See A102430 thru 433
BIG CREEK FLOOD CONTROL PROJECT

PHASE II

GENERAL DESIGN MEMORANDUM

AUGUST 1979

PLATE C14

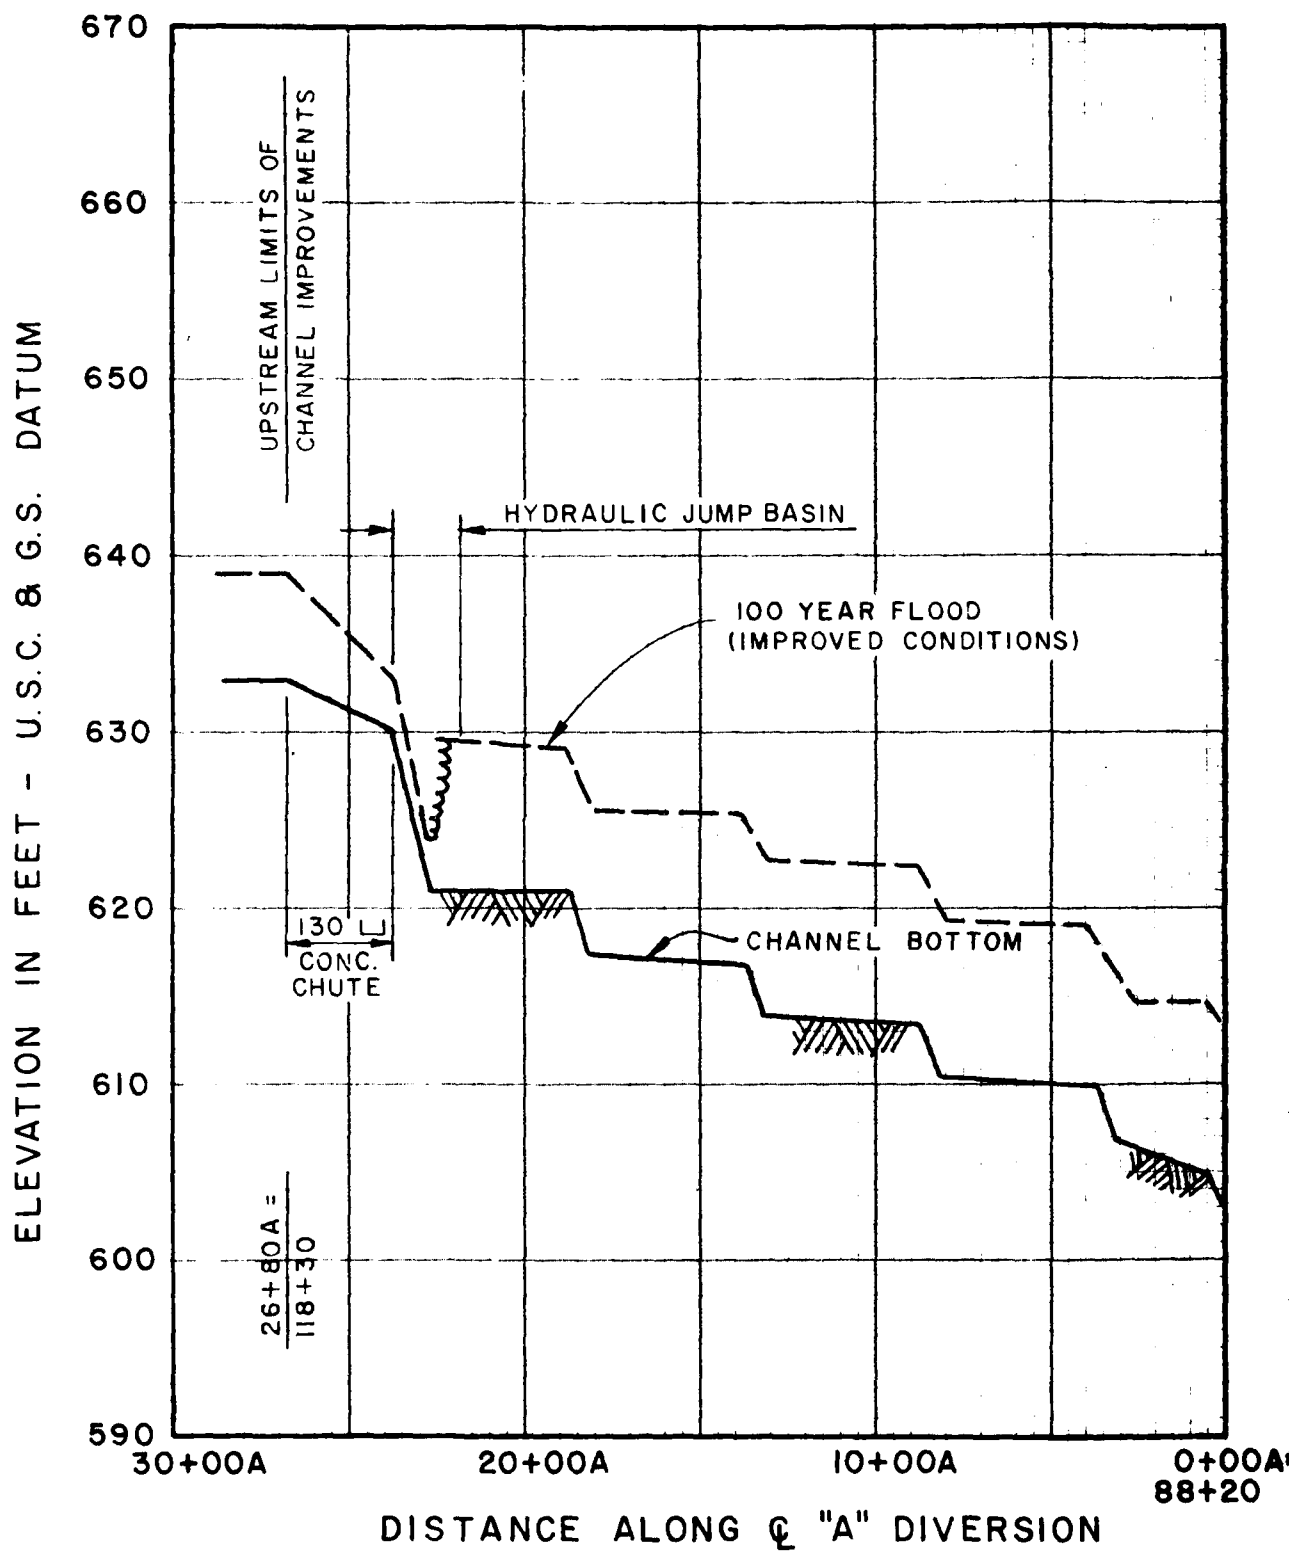
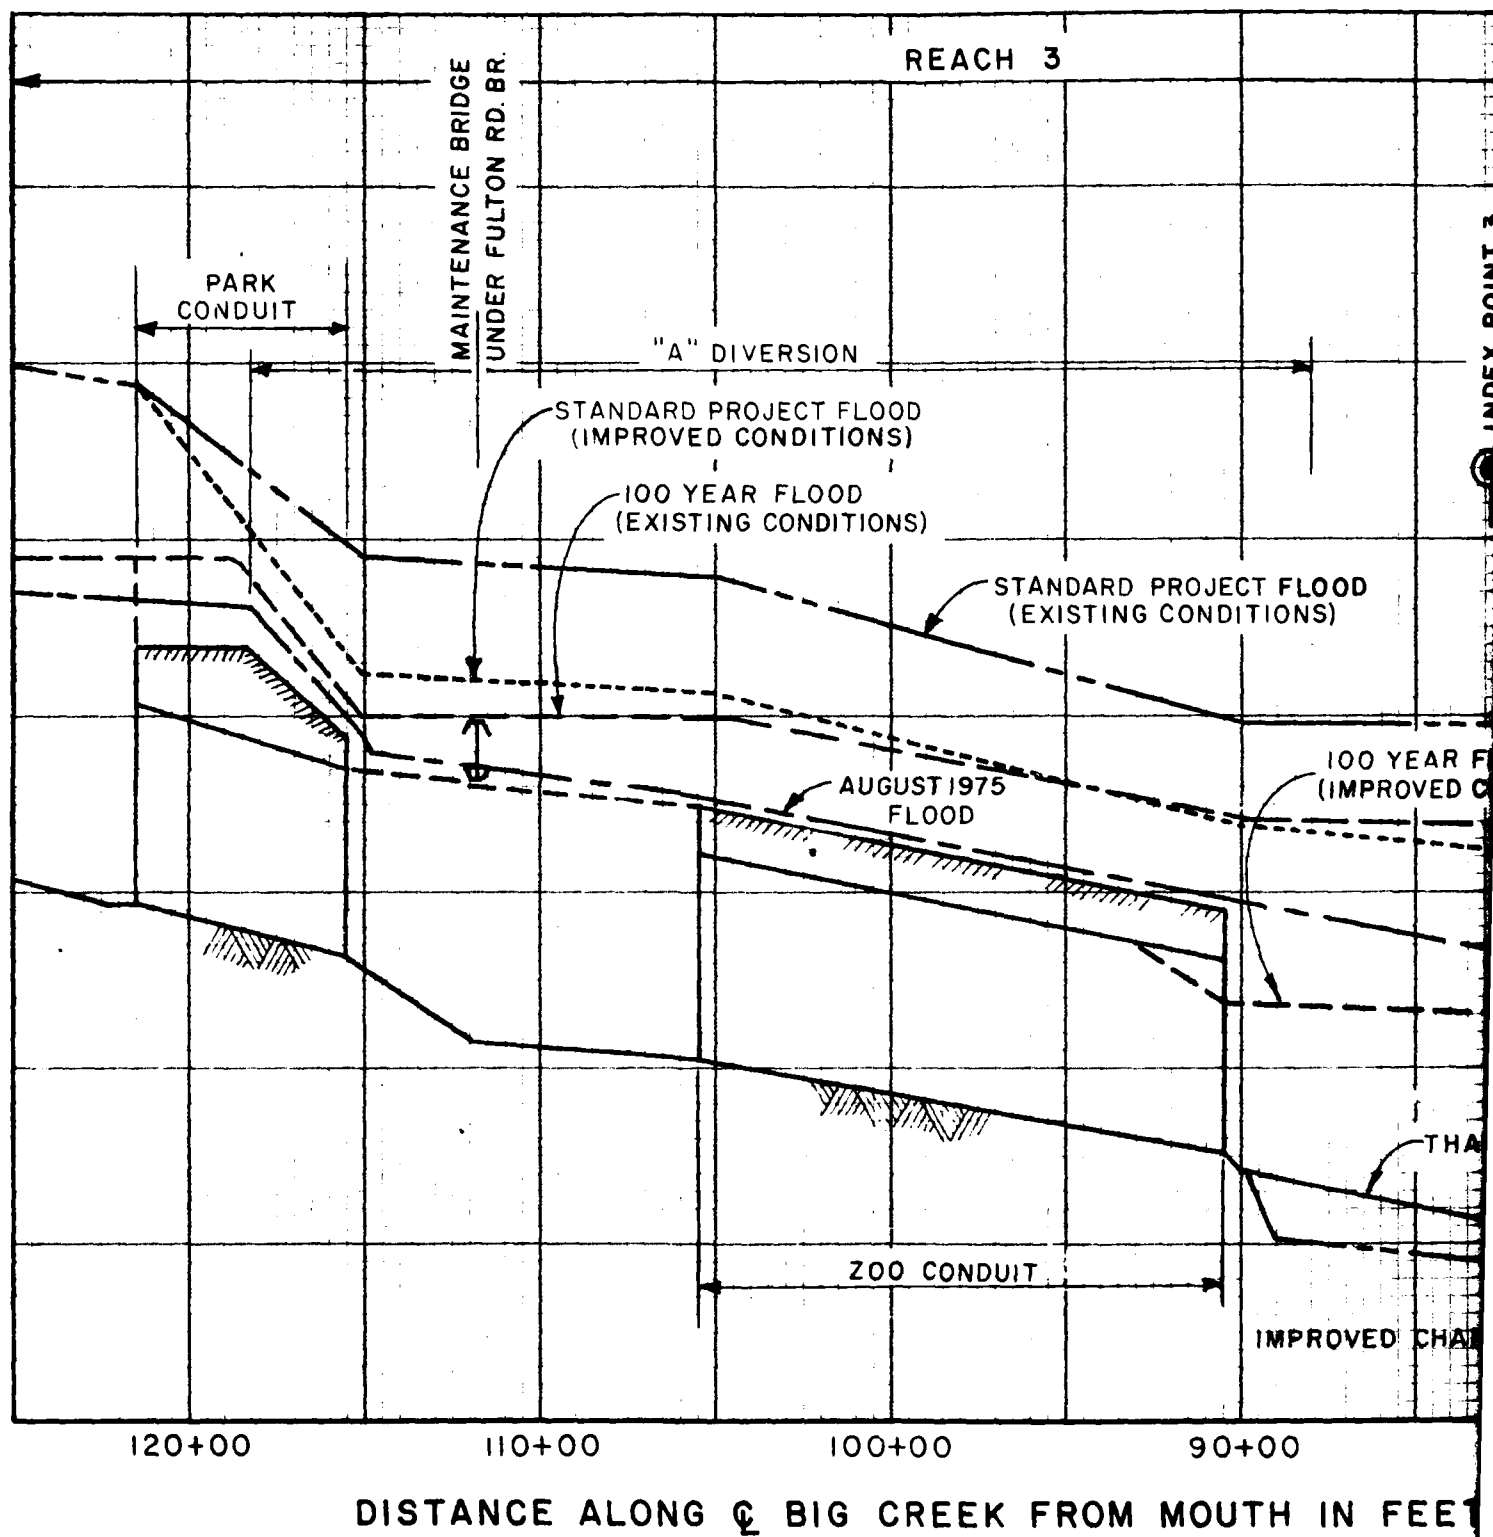
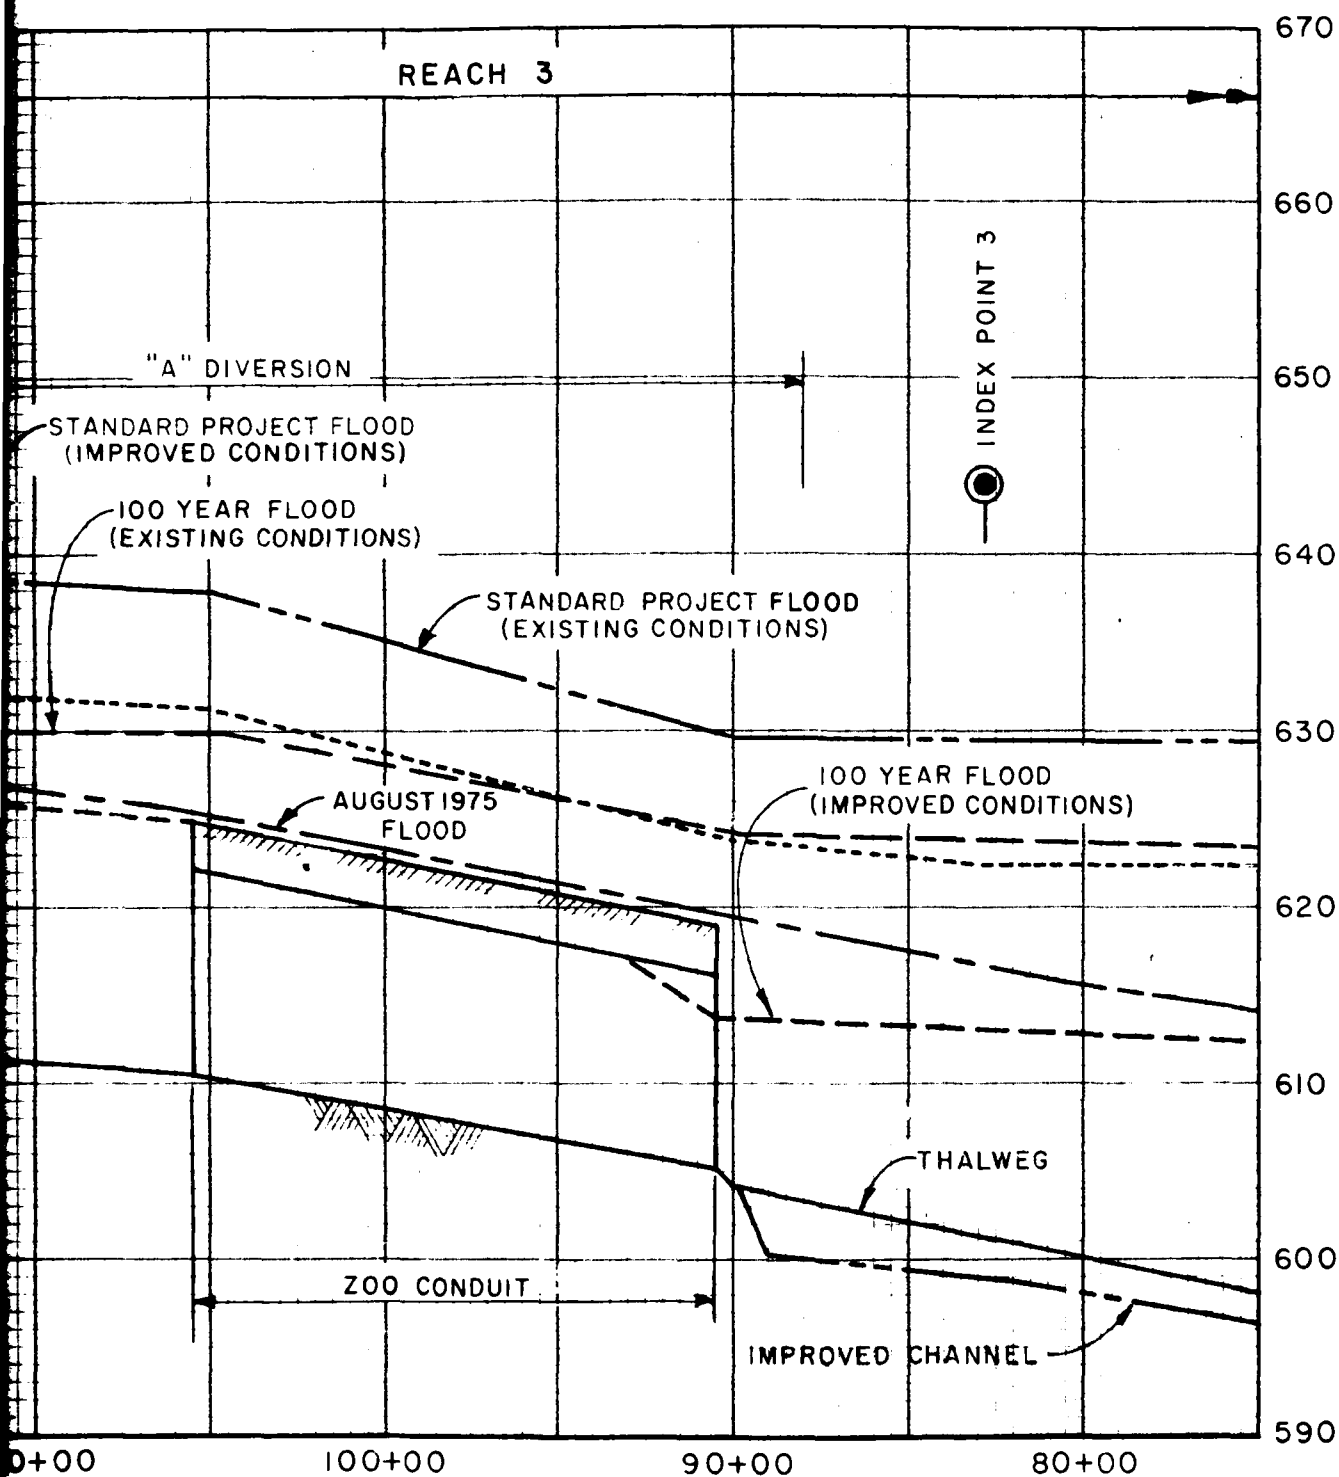
b. Plate C-15. The water surface profile along the "A" Diversion is unrealistic. The correct computer profile should be plotted and should approximate an M-2 profile since the control is near the drop for each step and the water surface appears to approach normal depth in the upstream direction in a channel having a mild slope.

m. Comment 12(b). Critical flow depths exist at all drops. The flow profiles next to these drops resemble the profiles near constricted flow openings. The flow profiles reach normal depth a short distance from the drop and were plotted from the back-water computation results. The scale on page C-15 is such that the profiles appear to be straight lines. Further, there is no significant effect of the water surface elevation near these drops based on the area around the floodway.
